AGENDA
Glen Ellyn Architectural Appearance Commission
Wednesday, November 9, 7:00 p.m.
Glen Ellyn Civic Center
Galligan Board Room
535 Duane Street

DRAFT MINUTES
ARCHITECTURAL APPEARANCE COMMISSION MEETING
October 12, 2022

FROM: Atrian Fard, Senior Planner
Brad Iwicki, Planning Intern

CLIENT: PROJECT NAME / ADDRESS / SHEET TITLE	
BRICK & MORTAR - GLEN ELLYN COWORKING OFFICE SPACES 411 MAIN ST., GLEN ELLYN, IL 60137	
GENERAL NOTES	
DATE	10/18/2022
PROJECT NUMBER	21898
SHEET NUMBER	G1

SIDE ELEVATION

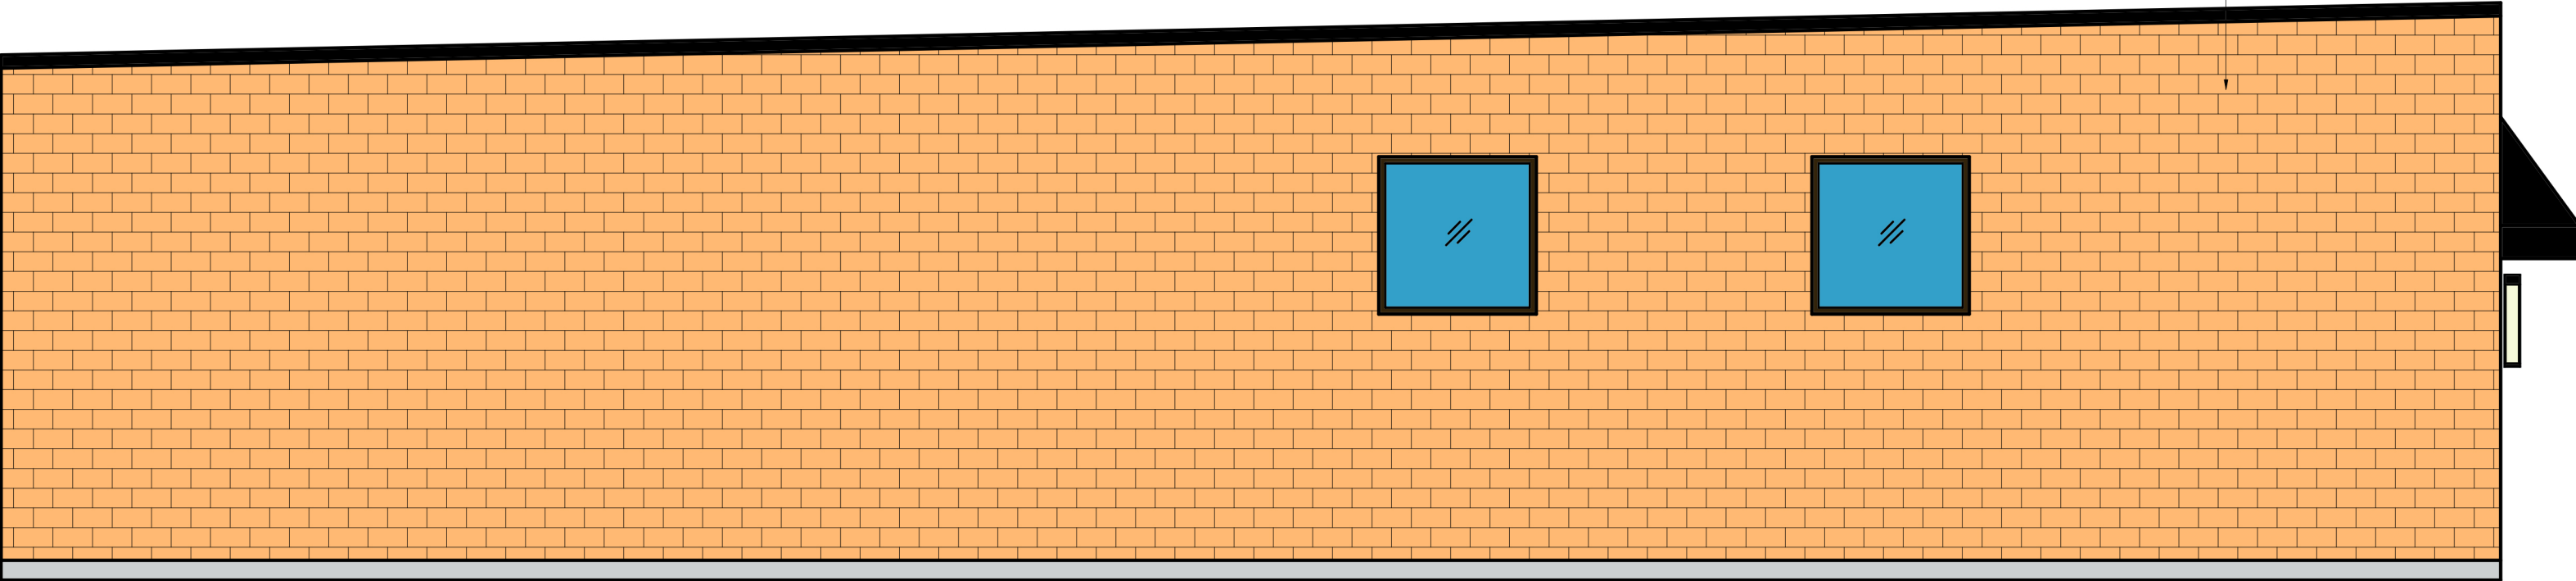
treatment, she said, is to be applied to the northern elevation. The *ARG*, she related, states that, "Original masonry wall surfaces should not be cleaned with abrasive methods such as sandblasting ... unless the building has no distinctive historic or architectural character." The rooftop equipment is currently screened by a 2- to 3-ft.-high parapet wall on three sides of the building, said Ms. Fard. The screen is made of light beige/gray Rolex Aluminum panels with flashing caps. As part of the renovation project, explained Ms. Fard, adding that the Petitioner intends to replace parts of the screen wall which are currently in disrepair, including metal studs and pressure-treated blocking, while maintaining the existing metal paneling, perhaps moving them a little. No changes to the color and materials are proposed, and the screen will match the building. The interior of the building will be renovated as part of the project to prepare the space for the new restaurant. A building permit has been applied for and is in process. Sr. Planner Fard provided a list of considerations the Commissioner might discuss.

Commissioner Albrecht said that given the topography the window arrangement makes sense, and favors the idea of fixing the brick on the alley wall. Sr. Planner Fard said she could inquire of the Building Department about less abrasive methods to remove paint. The Petitioner said there isn't much brick on the front, but isn't opposed to keeping it. Commissioner Goronov said he likes the idea of what appears to be limestone, and favored the idea of continuing it along the base of the west elevation as an accent, cleaning the brick above. Ms. Xim'enez said she isn't sure how aesthetically pleasing this treatment would be. Not knowing the streetscape specification for a tree in front of the building, the Petitioner expressed ambivalence about leaving an awning, given her experience replacing several because of sap damage. Commissioner Goronov recommended looking at the whole elevation. Commissioner Mees said it would be great to see a rendering without the awning, as losing it would be a "big change," and asked about signage. In lieu of a printed awning, Ms. Xim'enez described a concept for an LED-illuminated, carved faux limestone feature. Commissioner Mees said she would like to see an illustration of this. Commissioner Rahn suggested painting the brick of the west façade a bold color, maybe with graphics or a mural.

GRIND AND CLEAN
EXISTING PAINTED BRICK
WALL. TUCKPOINT AS
NEEDED.

NEW COLOR TO BE
EXISTING NATURAL
BRICK COLOR.
YELLOW/ORANGE
COMMON BRICK.
